Addendum No. 1
August 23, 2024

Project: KOA – Rapid City Office
Rapid City, South Dakota
#3017

Architect: Architecture Incorporated

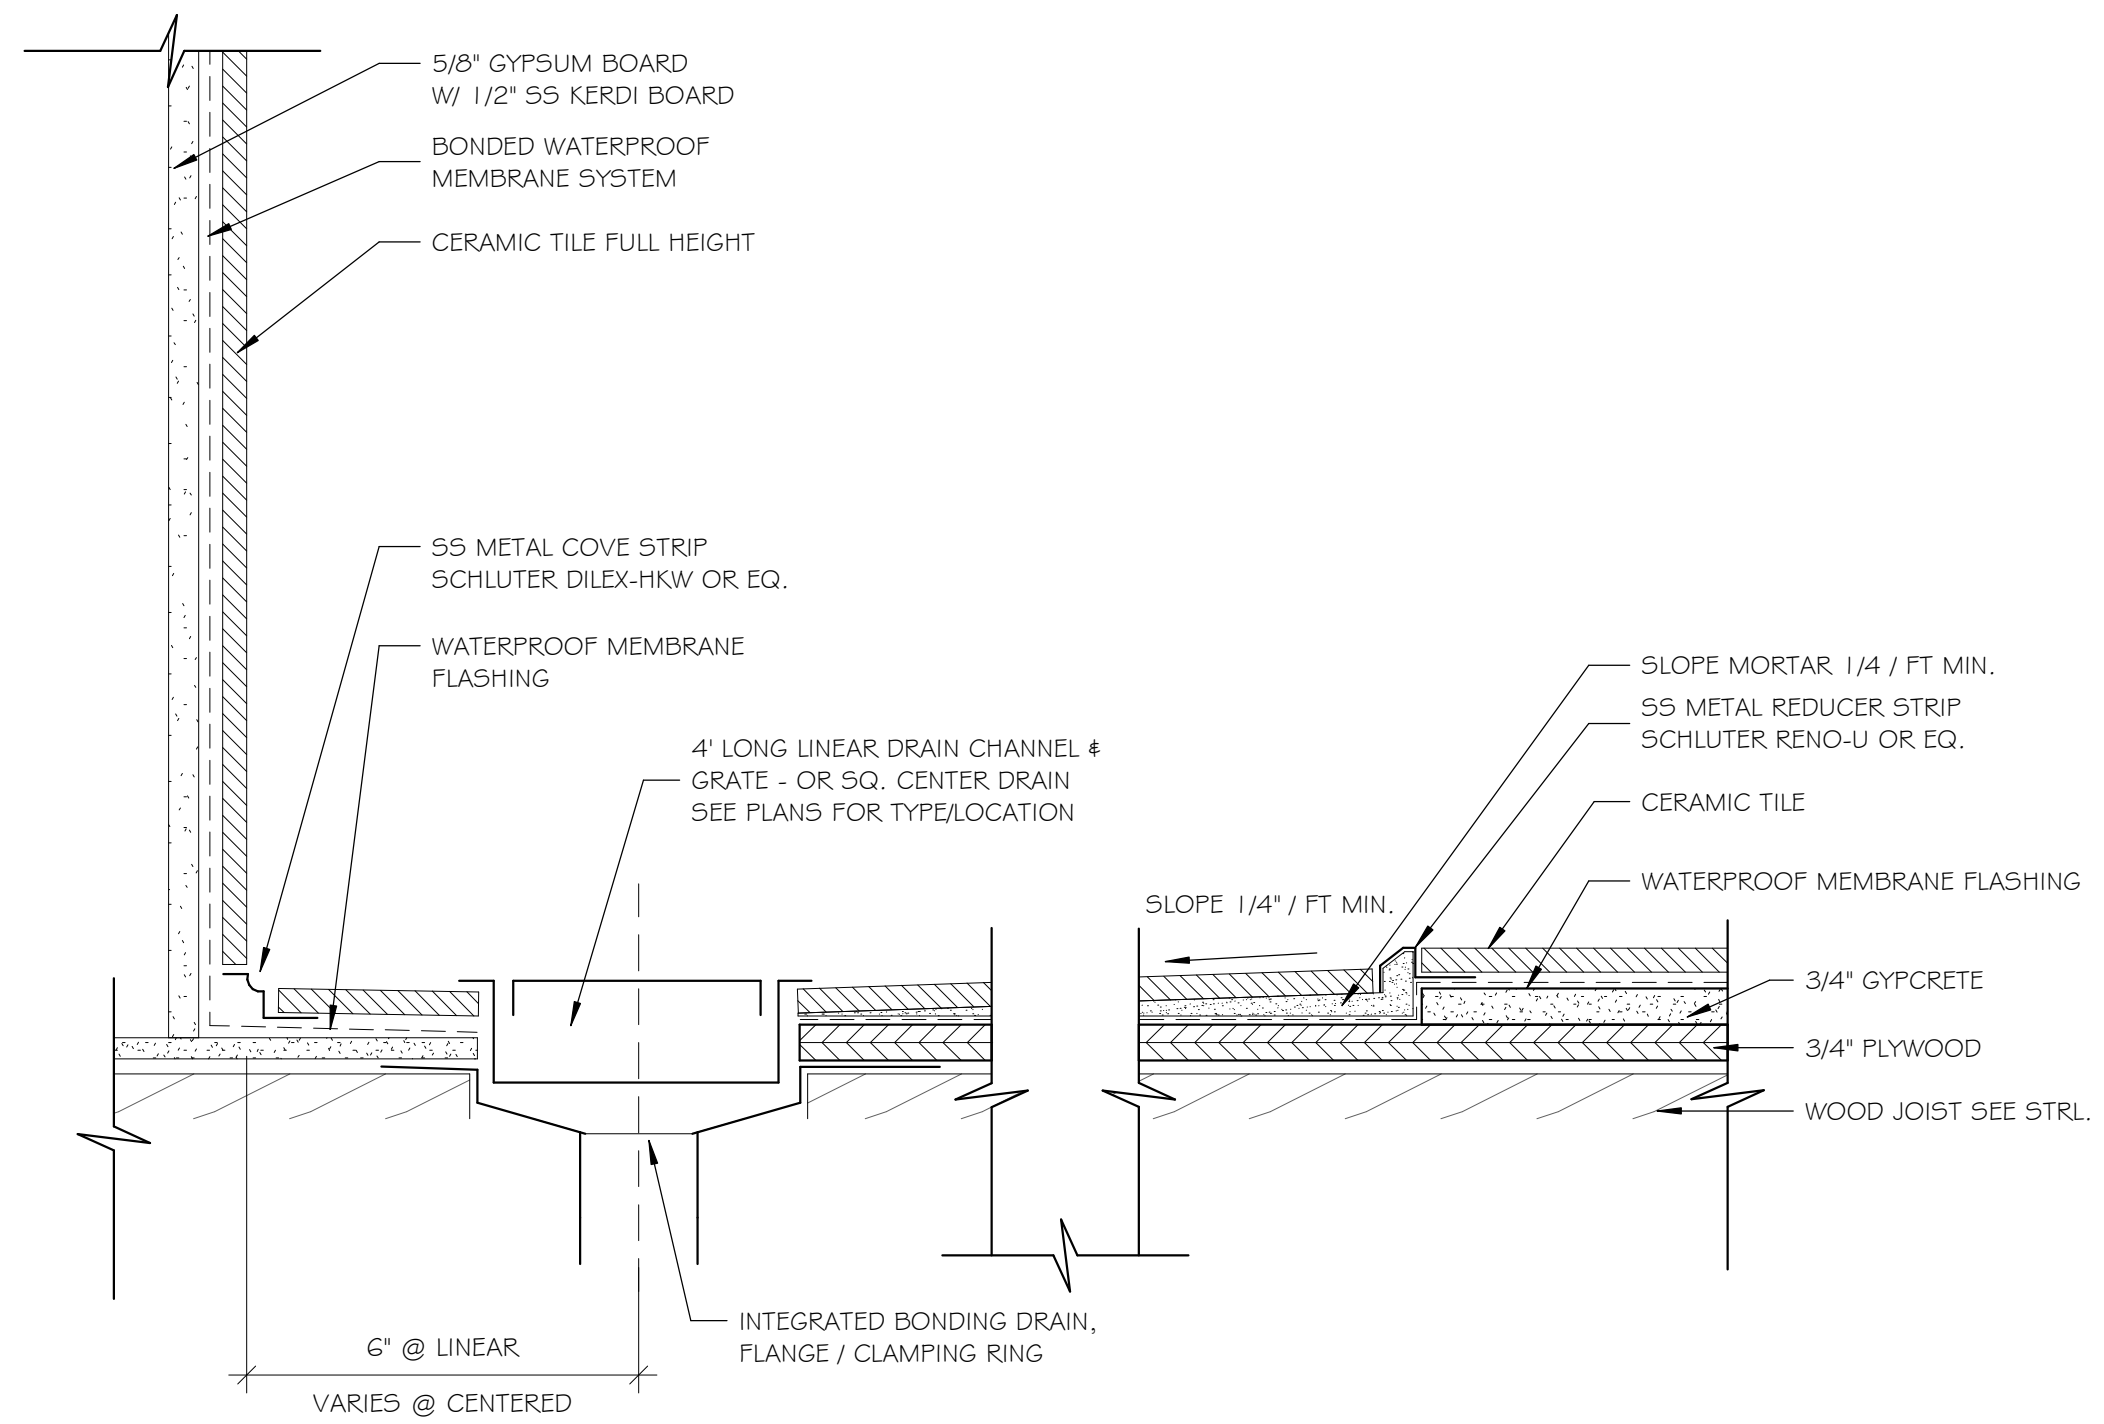
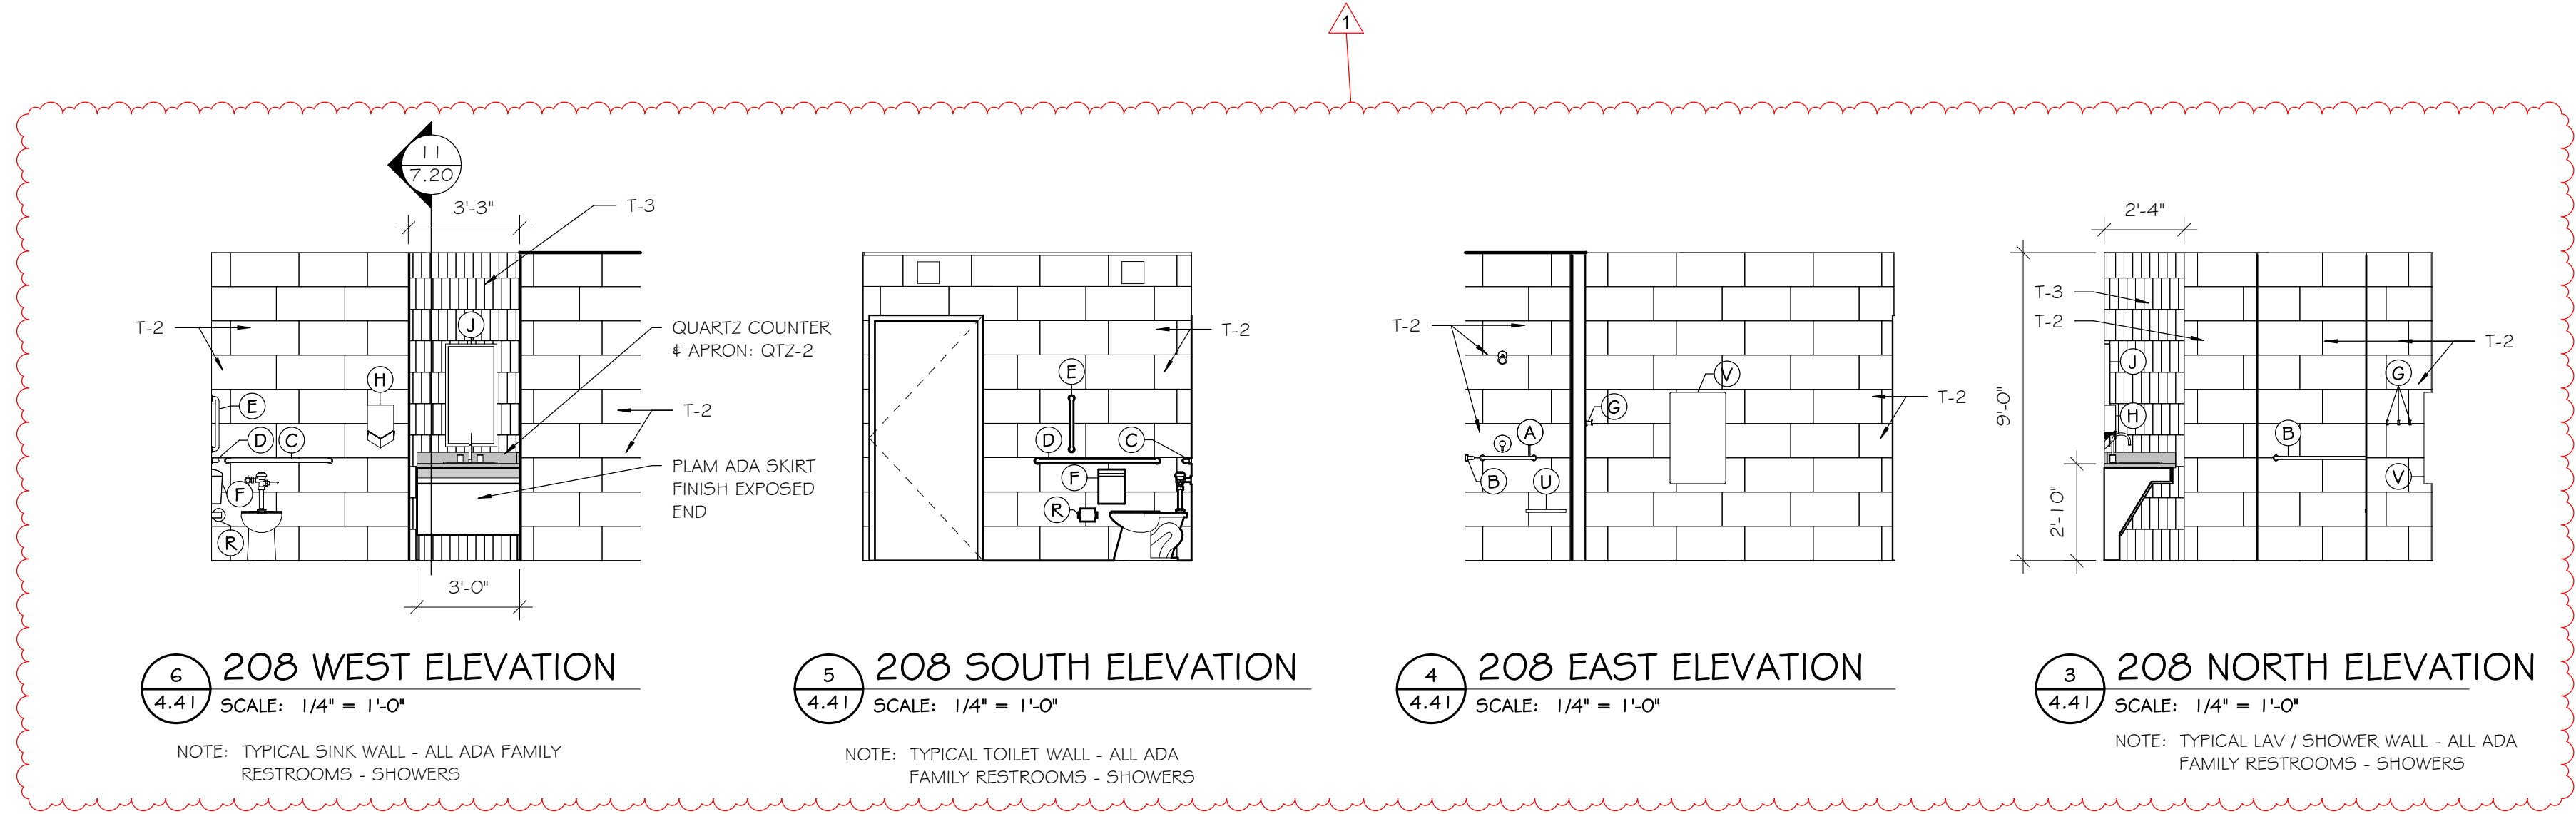
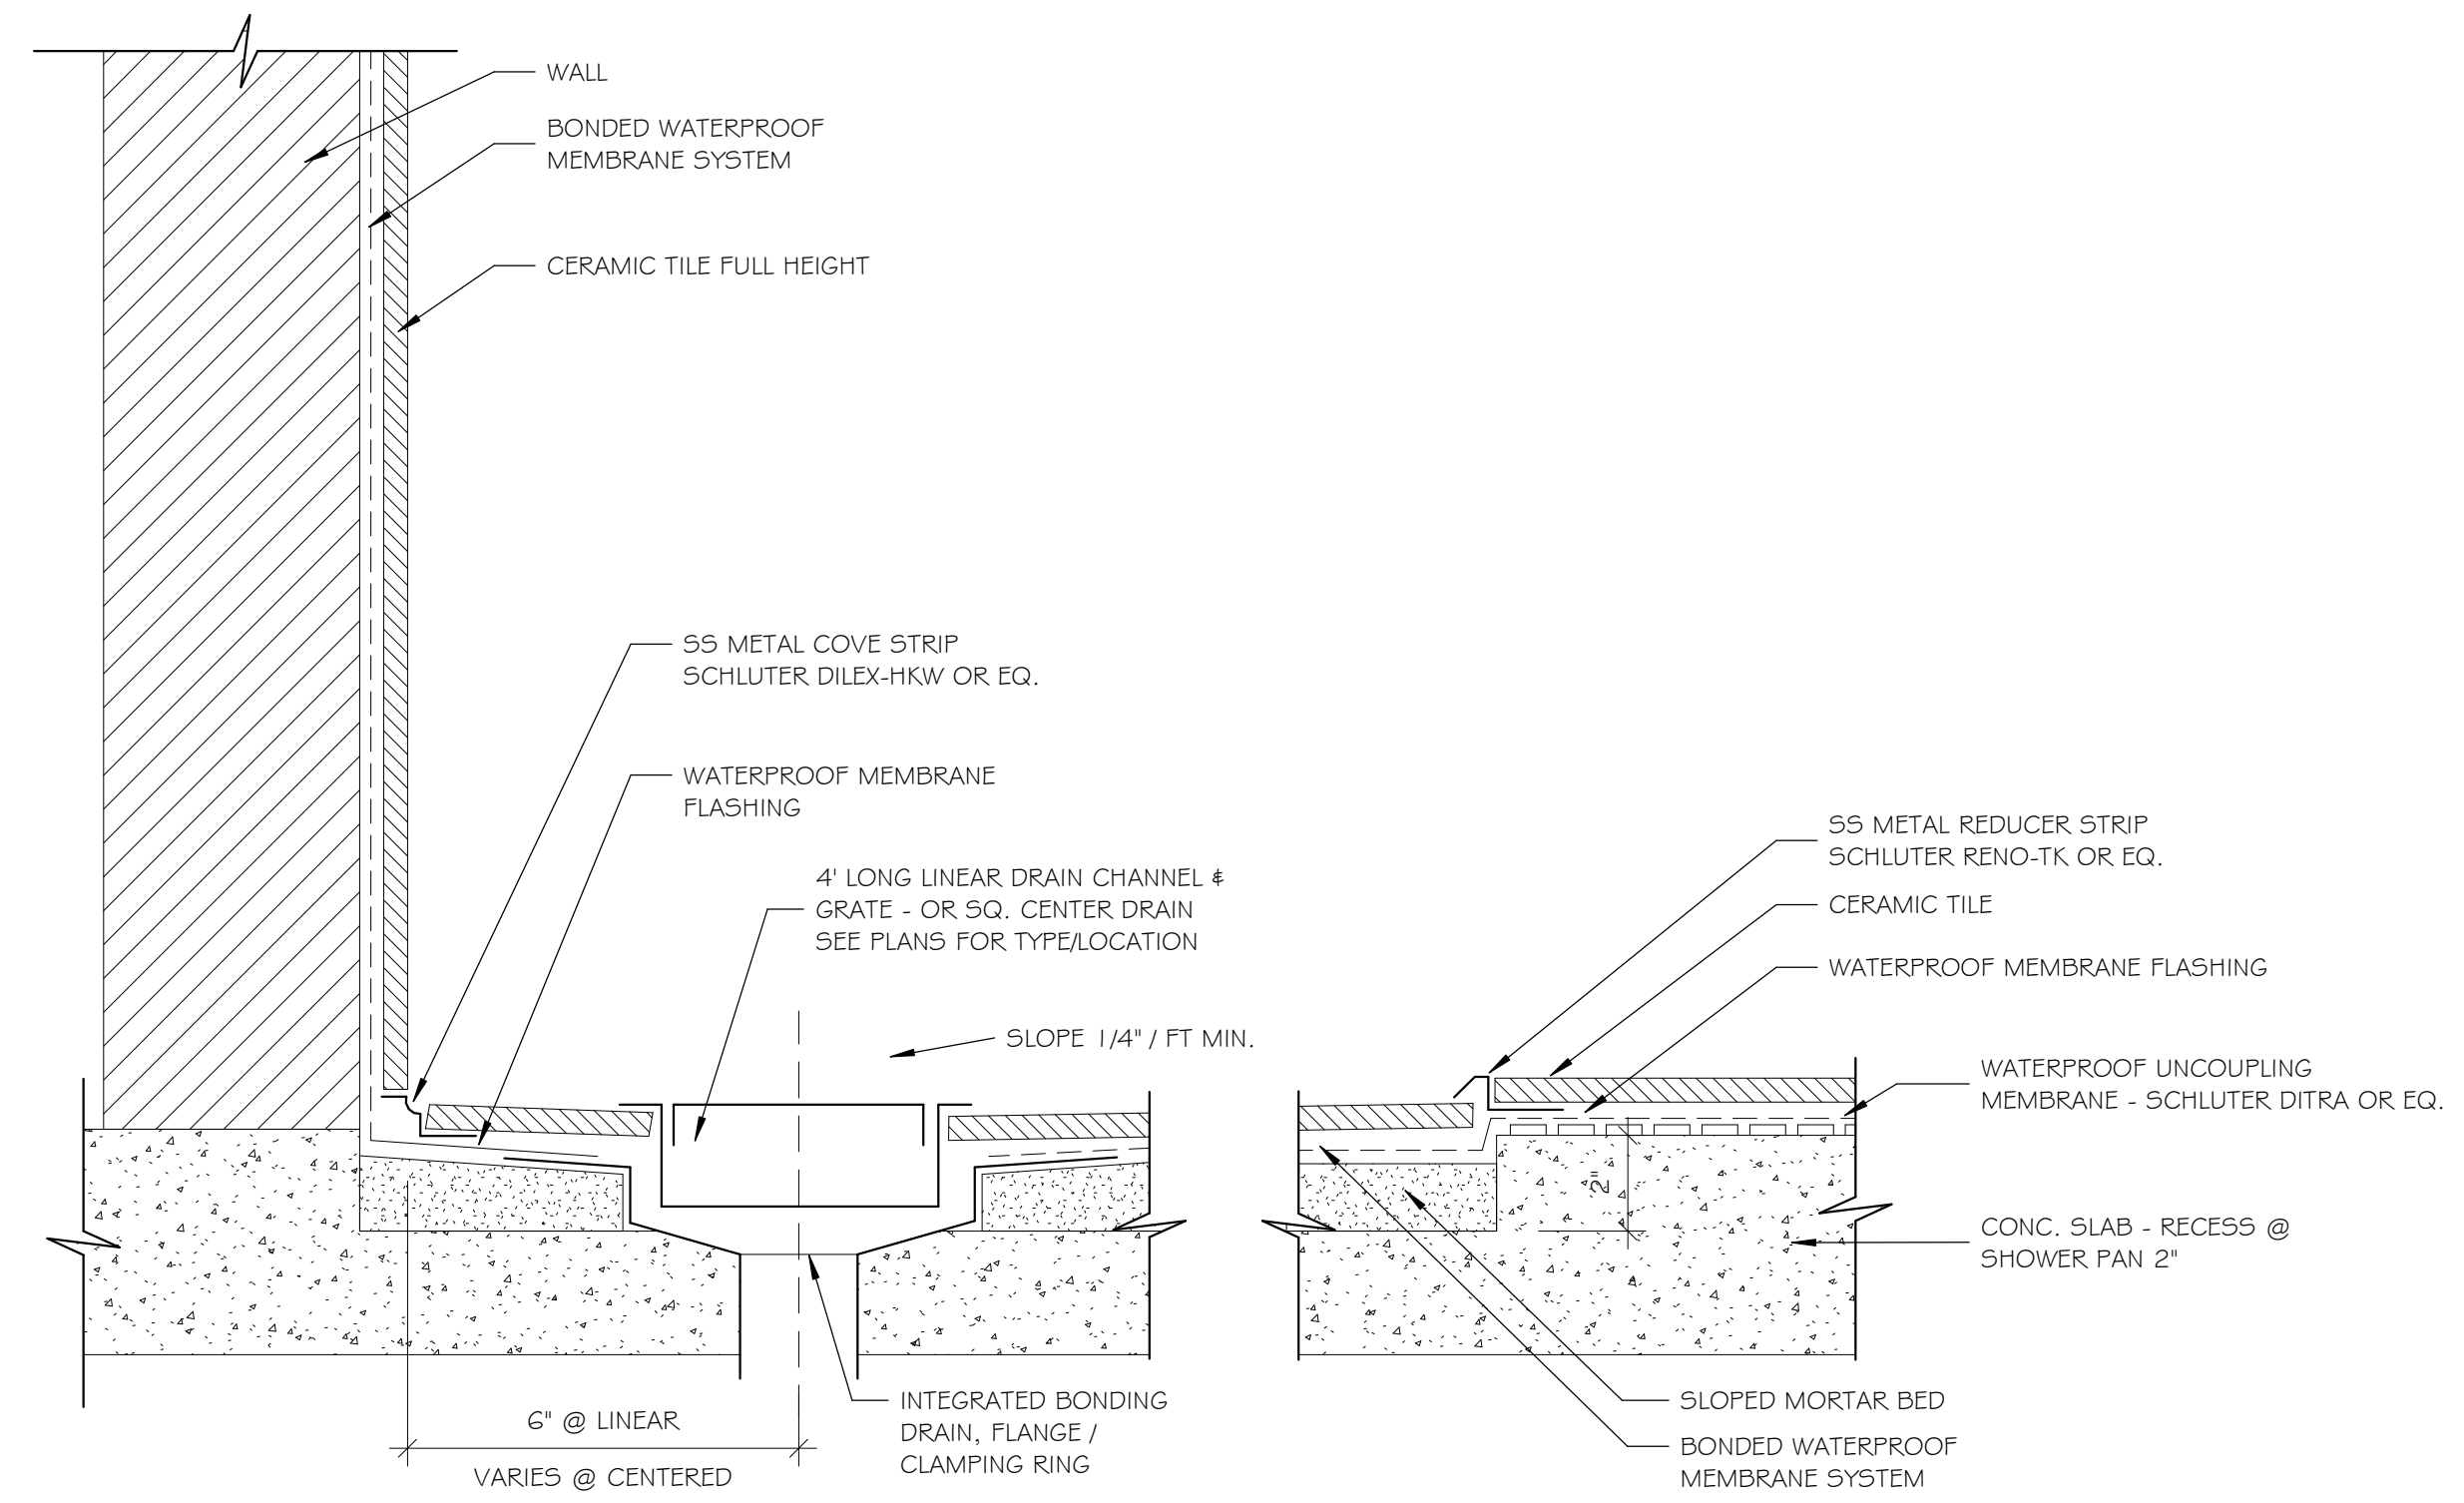
11) DRAWING 4.41 –ENLARGED PLANS

- a) Change sheet title to “TO INTERIOR DETAILS & ELEVATIONS”.
- b) Elevation 6/4.41: Add section reference 11/7.20 and see added noted and dimension on elevation 3/-6/7.20.
- c) Revised sheet 4.41 is attached, with changes clouded and noted as “1”.
